Addendum 1
Solicitation 24-99428
Brighton Beach Road Reconstruction

ADDENDUM #1, Thursday, April, 2024

Brighton Beach Road Reconstruction
City Project # 1940
BID No. 24-99428

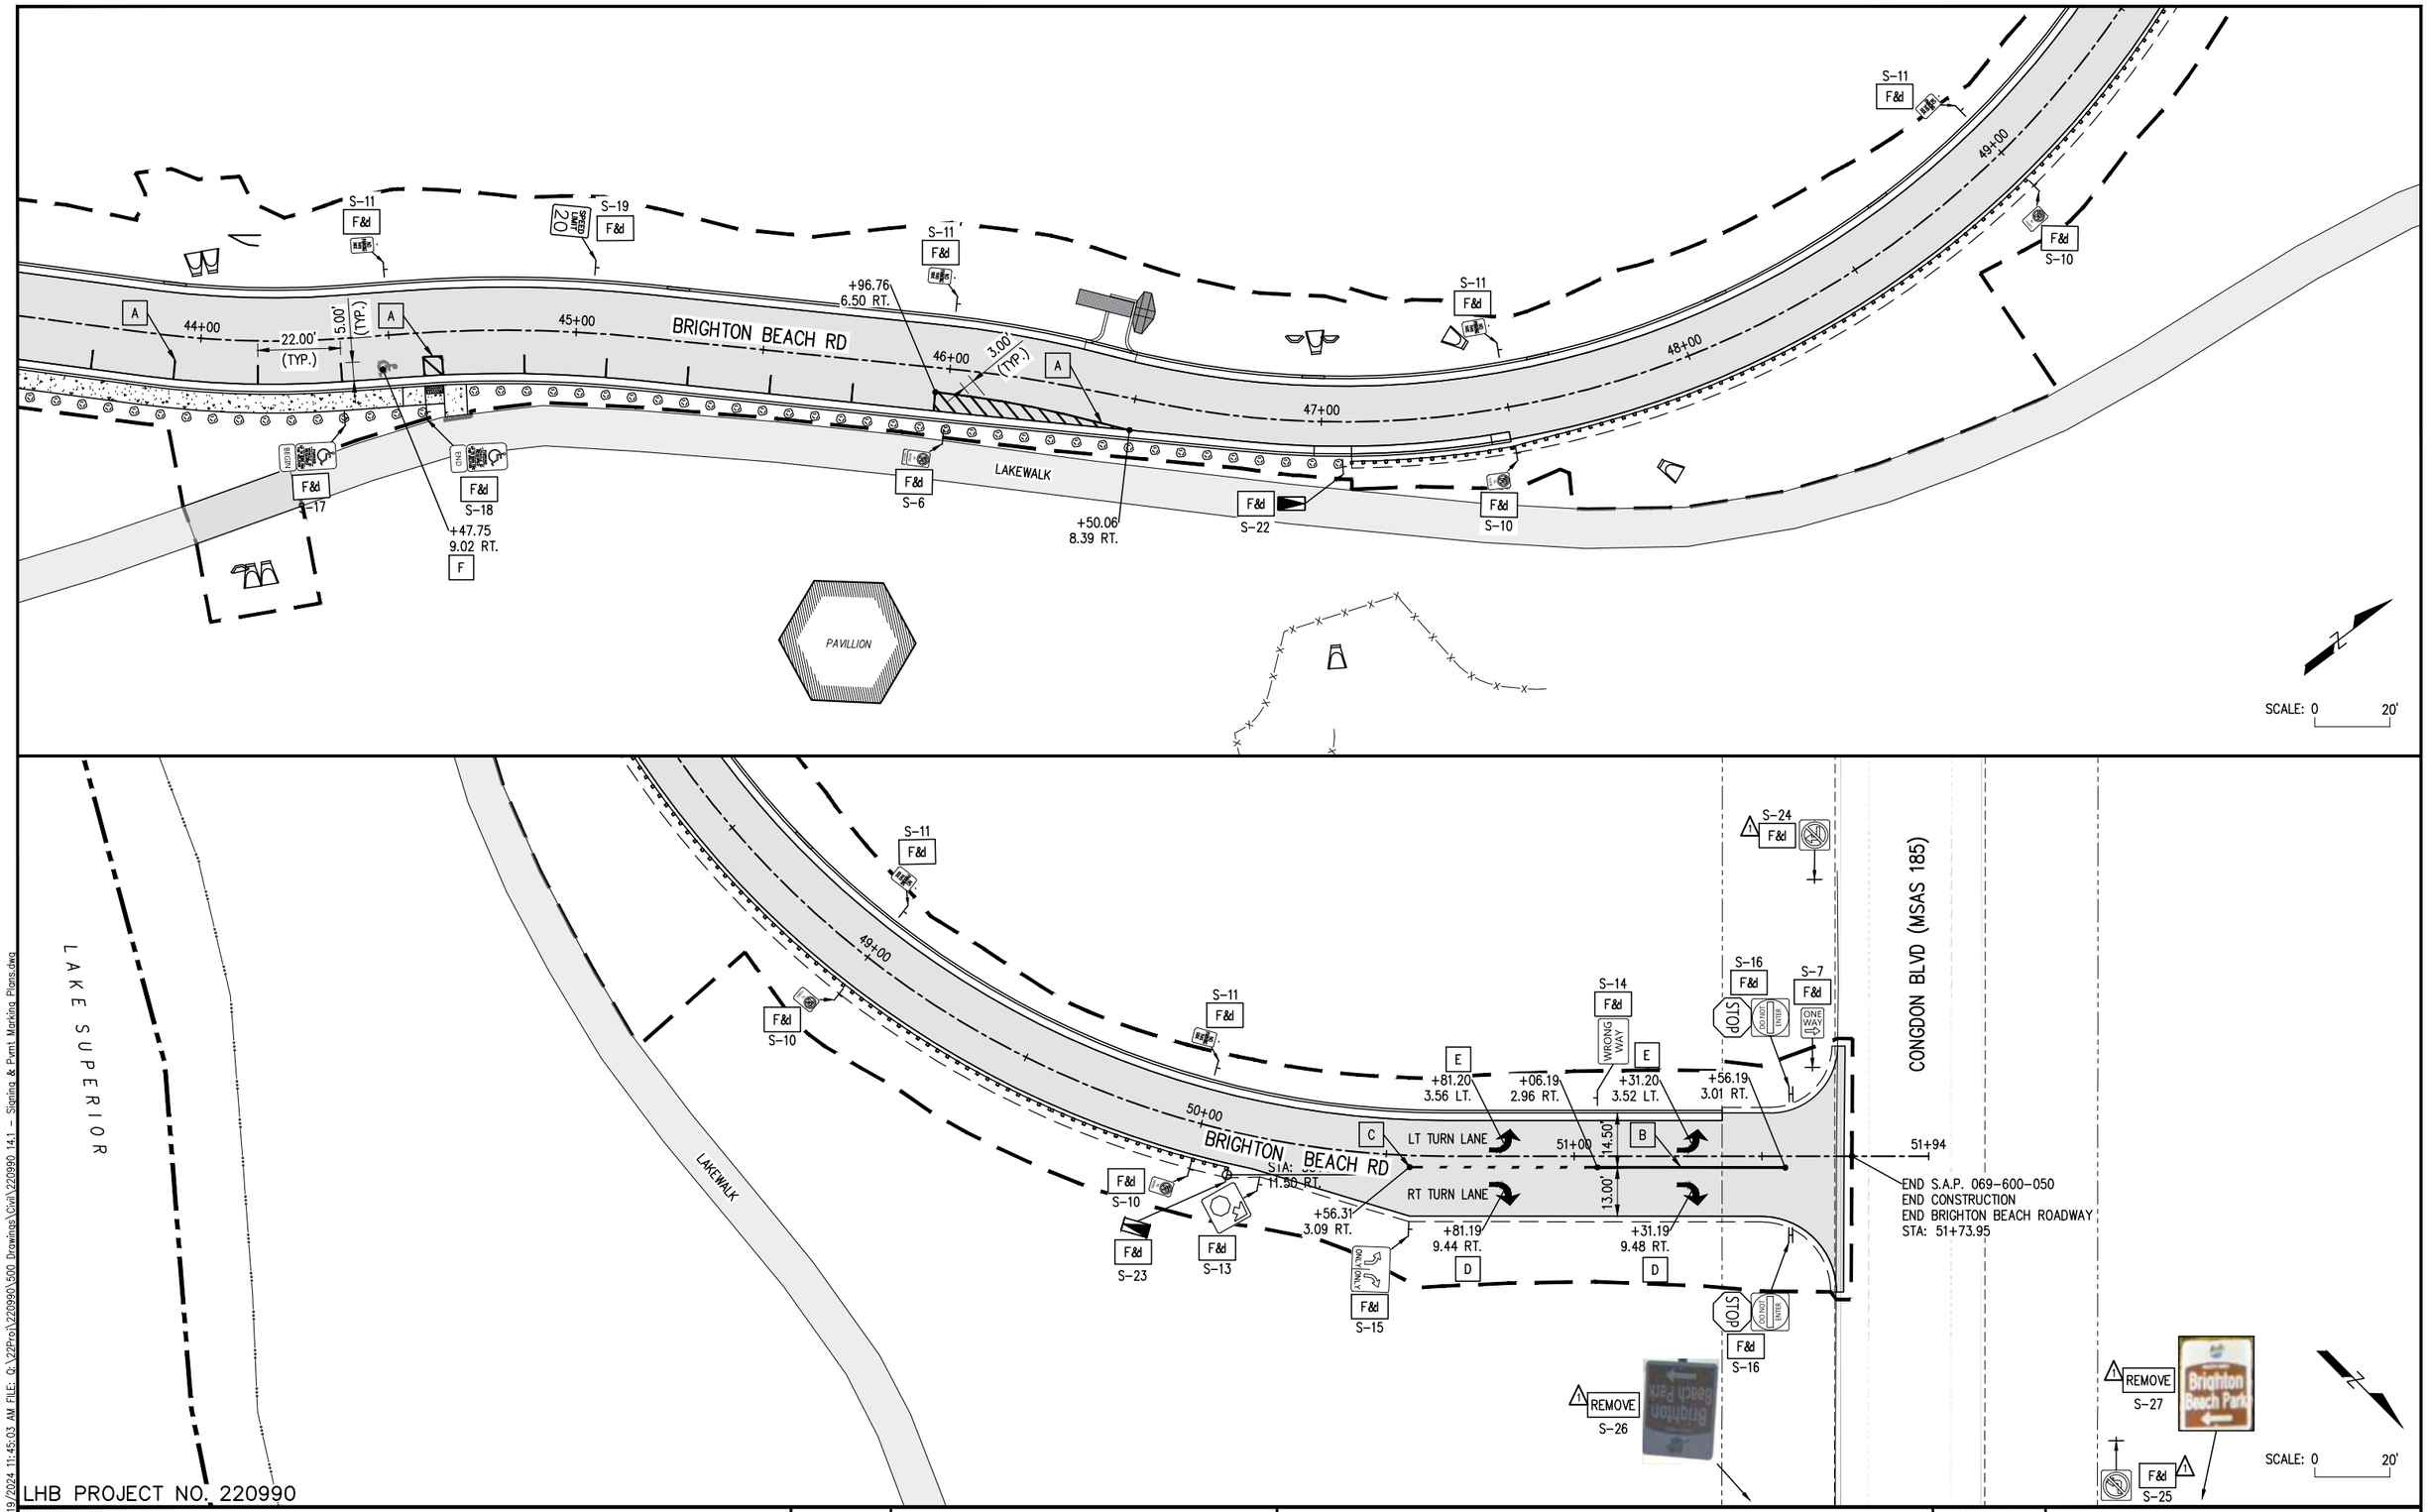
6. Drawing changes to the CONSTRUCTION PLAN & PROFILE are as follows:
    a. Sheet 68; Modify Sheet 68 to show removal of walk between Sta 44+70 and 46+00 and shifting boulders between trail and curb.
